Assessment report to Sydney Central City Planning Panel

Panel reference: PPSSCC-259

Development application

DA number	SPP-21-00007	Date of lodgement	31 May 2021
Applicant	IRM Property Group (No)2		
Owner	IRM Property Group (No)2		
Proposed development	Construction and operation of a warehouse and distribution facility including main ancillary offices, hardstand loading docks, provision of 281 car parking spaces, signage, retaining walls and emergency private access road.		
Street address	Archbold Road, Eastern Creek being Part Lot 2 DP 1145808, Part Lot 1 DP 1145808 and Part Lot 2 DP 1247691		
Notification period	1 to 15 July and 20 September to 4 October 2021	Number of submissions	1

Emergency access into and out of subject site

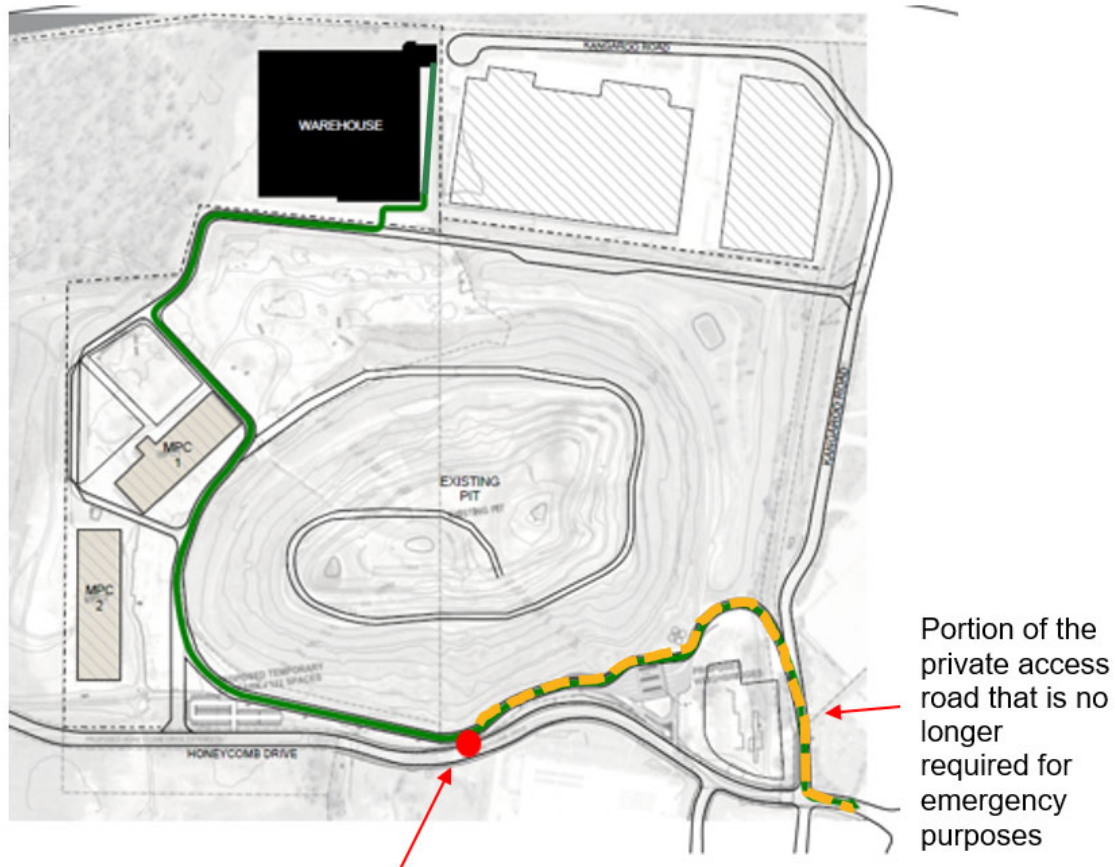
Without the connection from Kangaroo Avenue to Archbold Road, no access will be provided to Archbold Road in the event of an emergency occurring at some point along the length of Kangaroo Avenue. In this regard, the applicant has owner's consent from Bingo Recycling and Ecology Park (being the property owner of this development application site and the land to the south of the site) to create an easement in gross for public access under S88E of the Conveyancing Act 1919 over the existing private driveway through the Bingo site on Lot 1 DP 1145808 and Lot 2 DP 1247691 next door. This will only be used in times of an emergency that blocks the existing private Kangaroo Avenue. This emergency access road will start at the end of Kangaroo Avenue cul-de-sac head through this development site and then on to the Bingo site leading back out to Honeycomb Drive (see below).

- 8.4.5 The location where this emergency access road meets Honeycombe Drive is already dedicated to Council as a public road. The driveway that has recently been constructed onto Honeycomb Drive (which is a public road) will be used as the emergency access point instead. This access point (red dot above) also shortens the length of the emergency access road substantially.

- 8.4.6 This will ensure that in the event of an emergency causing Kangaroo Avenue to be closed, any emergency vehicles or trapped workers and their vehicles will be able to enter or leave this site using this easement for public access to be situated at the end of the existing cul-de-sac through the site southwards along the site's eastern boundary and to the end of the site at its south eastern corner. This will join onto the existing gravel road in the Bingo site and back out to Honeycomb Drive.

- 8.4.7 This option was assessed by our traffic officers who do not have any objections to this emergency private road subject to creation and registration of the proposed emergency private road as an easement in gross benefitting Council. This easement will also require the emergency private road to be constructed to Council's standards to withstand wear and tear from heavy vehicles. This is to be achieved through the creation of an easement in gross for public access over the subject land and adjacent land being Lot 1 DP 1145808 and Lot 2 DP 1247691 (the Bingo site) using S88B of the Conveyancing Act 1919 benefitting Council and the public at large. The same easement in gross will also have to be registered on the title of the Bingo site for the length of the emergency egress route. Conditions of consent have been imposed accordingly as part of the deferred commencement consent to ensure the easement and upgrade of this private access road occurs prior to the consent being activated. A Voluntary Planning Agreement has also been executed between Council and the developer that requires the creation of the

above easement in gross for emergency access over part of the land in favour of Council.
